SURRY POWER STATION, UNIT NO. 2

Amendment No. 58
License No. DPR-37

ATTACHMENT TO LICENSE AMENDMENT NO. 58

SUPPORTING AMENDMENT NO. 58 TO LICENSE NO. DPR-37

HOT CHANNEL FACTOR NORMALIZEDOPERATING ENVELOPE

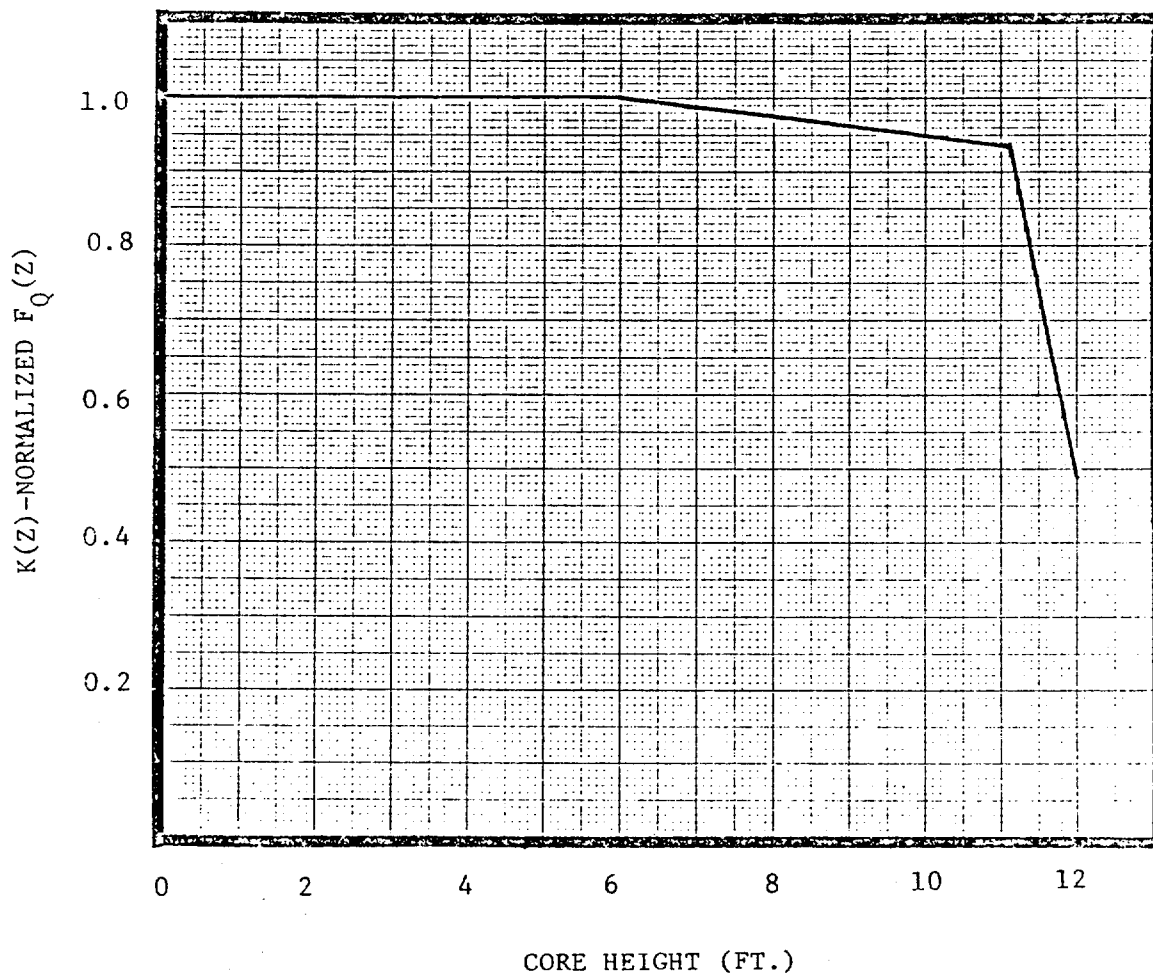
where P is the fraction of rated power at which the core is operating, K(Z) is the function given in TS Figure 3.12-8a for Unit 1 and Figure 3.12-8b for Unit 2, Z is the core height location of F_Q , and T(BU) is the interim thimble cell rod bow penalty on $F_{\Delta H}^N$ given in TS Figure 3.12-9.

- (a) Change of the heat flux hot channel factor, F_Q to 2.19, the limiting enthalpy rise hot channel factor to 1.55 and the corresponding limiting assembly enthalpy rise factor to 1.476 for plant operation with 3 percent of steam generator tubes plugged.
- (b) Change of the Hot Channel Factor Normalized Operating Envelope for Unit 2 (TS Fig. 3.12-8b).
- (c) Removal of the specifications for the augmented surveillance of core power distribution and change of the axial flux difference limits (TS Fig. 3.12-10).

AXIAL FLUX DIFFERENCE LIMITS
AS A FUNCTION OF RATED POWER
SURRY POWER STATION

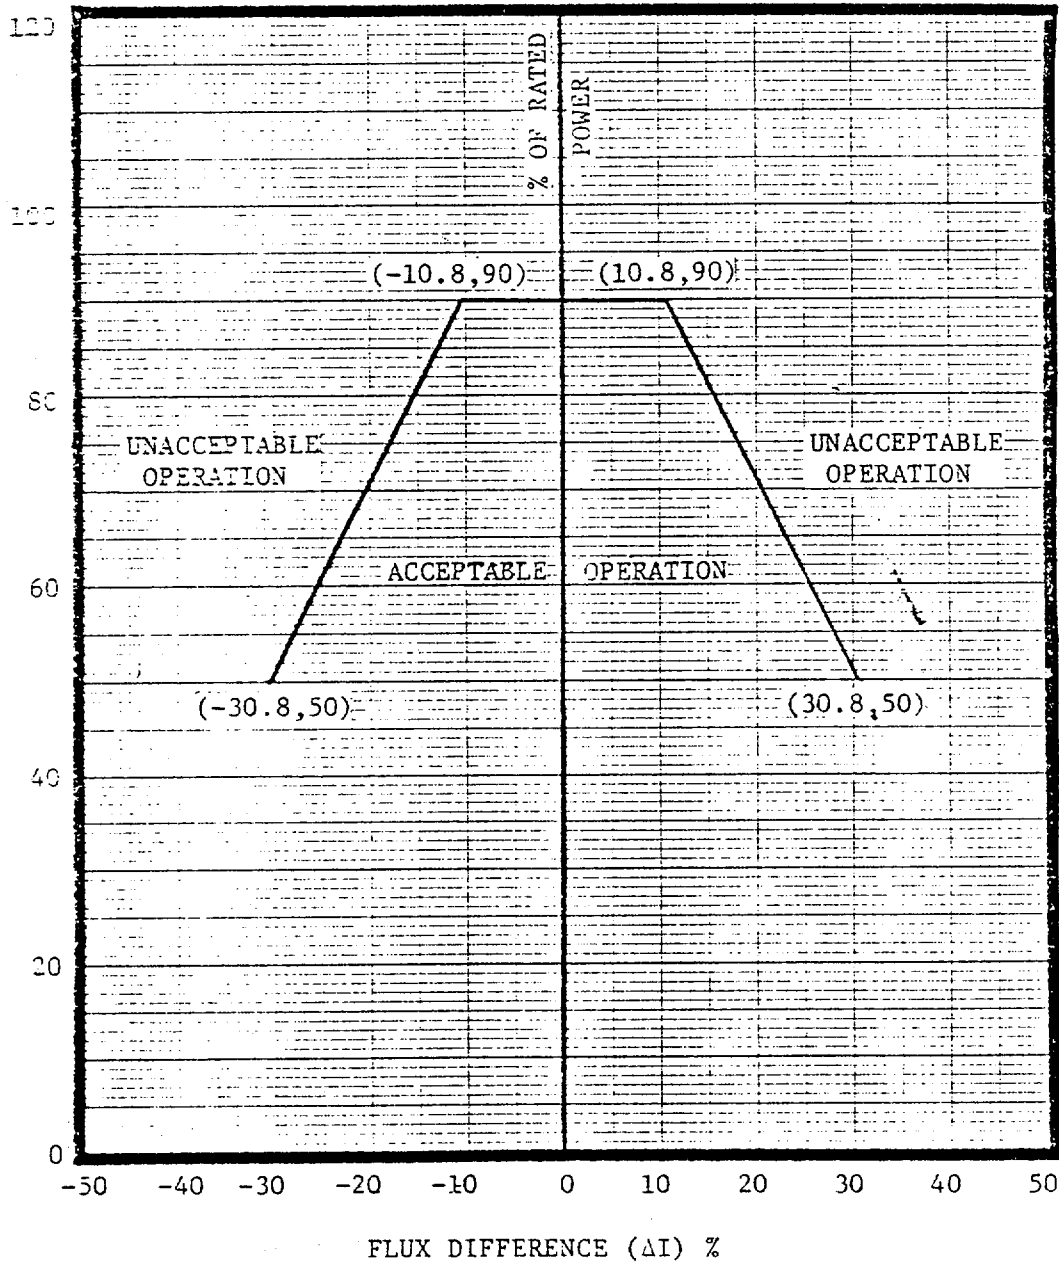
- b. At a power level no greater than 90 percent of rated power,
 - (1) The indicated axial flux difference may deviate from its target band for a maximum of one hour (cumulative) in any 24-hour period provided the flux difference is within the limits shown on Figure 3.12-10.
